IMPORTANT SAFETY RECALL

NHTSA Number: 25V-897 (School Bus)

SUBJECT: R26DY: Electric Vehicles May Shut Down

R26DY – Electric Vehicles May Shut Down

Figure 1

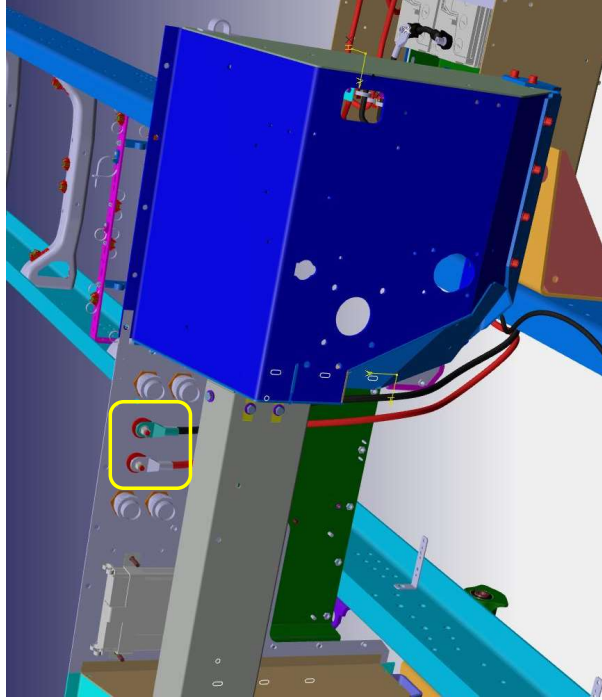
1. Remove negative battery cable from 12v Battery bank and secure.
2. Replace both positive and negative DCM pass through studs. (See Figure 1 & 2)
3. Service locations highlighted in Figures 4 - 7. Any connections/components found to have any thermal stress MUST be replaced.
4. Clean/prep connection(s) per Figure 3, and torque per legend on Page 2.

Figure 8

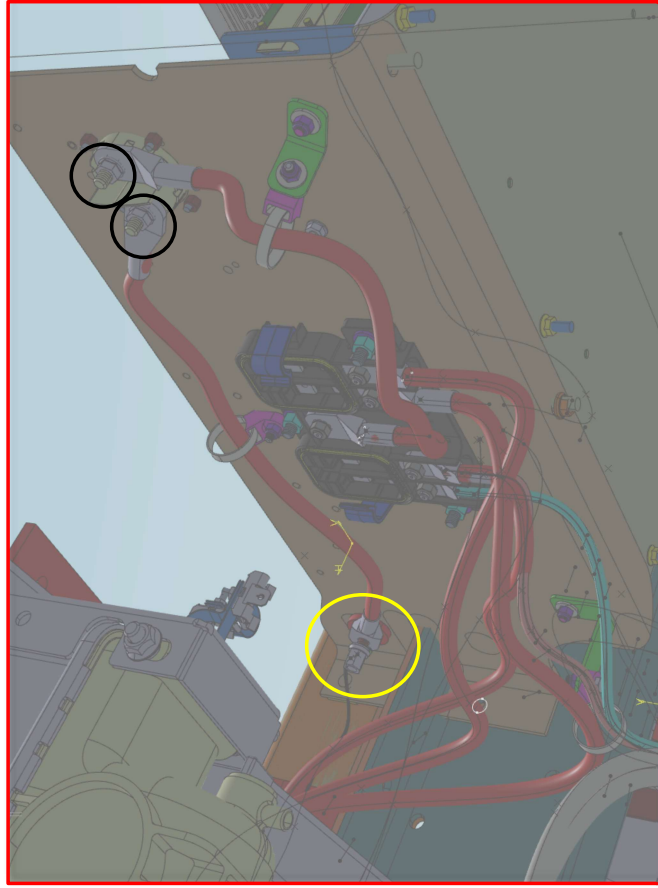
1. Remove negative battery cable from 12v Battery bank and secure.
2. Service locations highlighted in Figures 8 - 12. Any connections/components found to have any thermal stress MUST be replaced.
3. Clean/prep connection(s) per Figure 3, and torque per legend on Page 2.

Figure 12

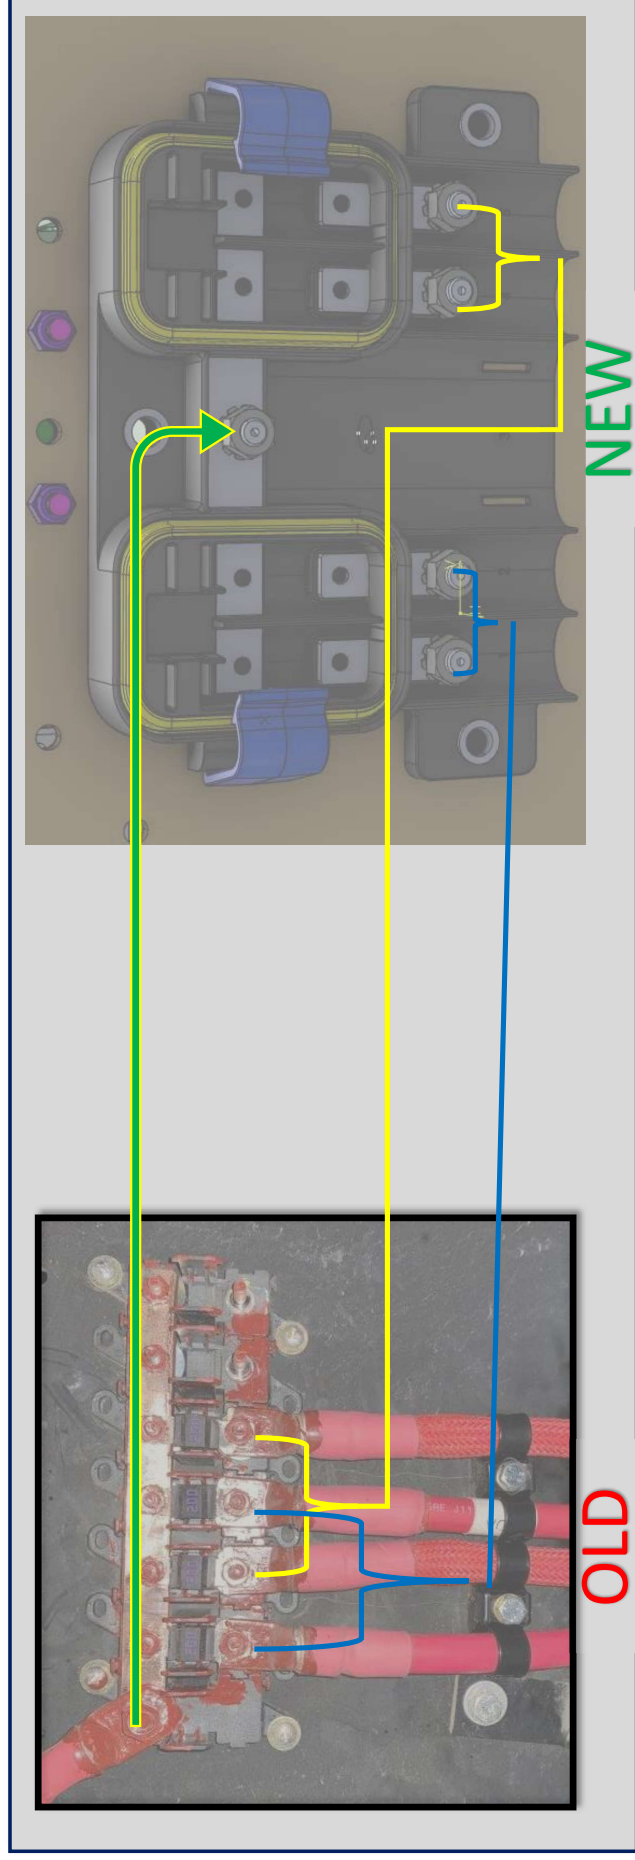
1. Remove battery negative cable and secure.
2. Remove all chassis cables from original BPDA and prep per Figure 3
3. Remove BPDA assy and install new BPDA per Figure 12
4. Torque connections on new BPDA per Figure 6
